**RE: RESPONSE TO INFORMATION REQUEST ROL/2026/54
 SECTION 13.2 OF THE DEVELOPMENT ASSESSMENT RULES
 17 COURTNEY DRIVE, UPPER COOMERA QUEENSLAND 4209**

We act on behalf of Courtney Upper Coomera Developments Pty Ltd, the Applicant in relation to a Development Application lodged with Gold Coast under the *Planning Act 2016* (the Planning Act) over the above land seeking:

- Development permit for Reconfiguring a lot (Impact assessment)

Figure 1 - Extract from CSMP showing temporary basin access track (see Attachment E)

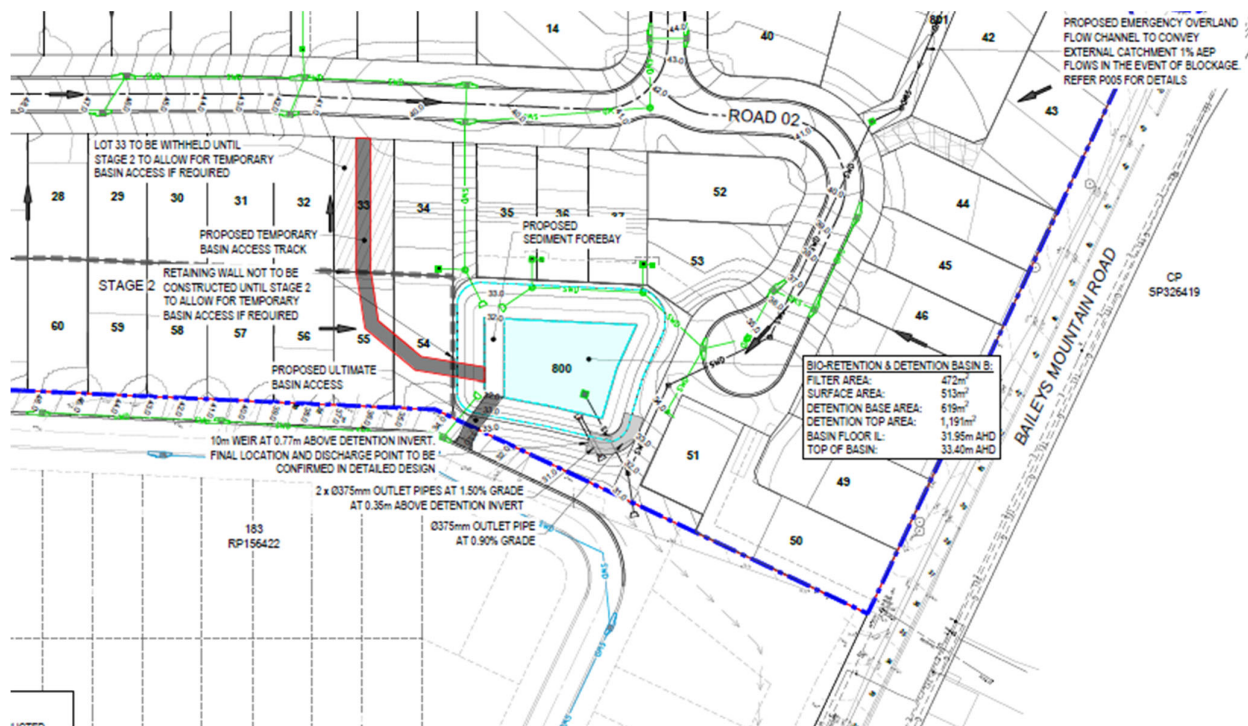
The proposed development defers Stage 2 (comprising of proposed lots 54 to 63) until such time as the proposed Road 02 within Stages 1 and 2 of separate ROL/2024/116 is delivered. City officer review of the proposed Statement of Landscape Intent (SLI), Preliminary Services Plan, and Preliminary Bulk Earthworks Plan are showing a vehicle crossing from the proposed detention basin in proposed lot 800 to the proposed Road 02. However, the detention basin is to form part of Stage 1a (which is not reliant on proposed Road 02).

The applicant is requested to provide an alternative outcome that ensures all components required to undertake Stage 1a can be wholly completed based on the infrastructure available to proposed Stage 1a.

Response: Provision has now been made for a basin maintenance track, via a temporary easement within Stage 1a and within the balance lot (being the future stage 2 lot). In particular, proposed lot 33 will be held for temporary access/maintenance purposes until such time as an ultimate access track can be delivered from new road within adjoining development. At such time as the ultimate track is established, the easement over Lot 33 can be extinguished and the lot made available for a Dwelling house. Retaining required for Lot 33 will be completed prior to the release of the lot as a Dwelling house lot.

See also Civil IR Response letter, including a Temporary basin access sketch (**Attachment C**) as well as the CSMP (**Attachment E**) for further information. An extract from the Temporary basin access sketch is included below and shows the interim/temporary and ultimate basin access track:

Provision is made for an easement over Lot 33 in Stage 1A, but given that Stage 2 can not occur until the road/services to the south have been delivered, we do not believe that the easement needs to extend over the balance lot (future stage 2 lot).

Figure 2 - Two tier retaining to Baileys Mountain Road (extract from LCP)

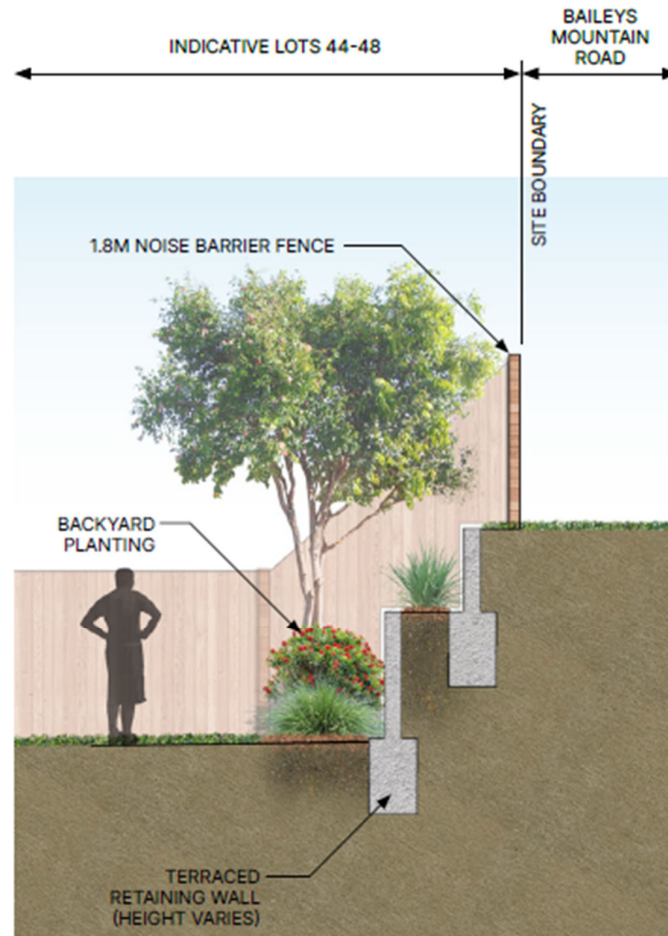
- *Sections detailing the interface between proposed lots 43 to 50 and Baileys Mountain Road. The sections should show the proposed retaining wall and acoustic fence outcome, including dimensions, materials and colours, etc.*
- *Amended drawings reflecting the proposed amended Stormwater Management Plan which utilises an emergency overland flow path. The emergency overland flow path must be shown within a separate drainage lot to avoid the possibility of a private landowner blocking the path. An easement is not considered adequate to achieve this outcome given the potential for risks to life and property if the drainage path is obstructed.*

Response: Refer to the Civil IR Response (**Attachment C**), the Engineering Infrastructure Report (**Attachment D**) and the LCP (**Attachment B**) for further details (including retaining and acoustic fence details) of the interface between proposed Lots 43 to 50 and Baileys Mountain Road, however for ease of reference, see the below extracts from the SLI which has been properly co-ordinated with the civil plans:
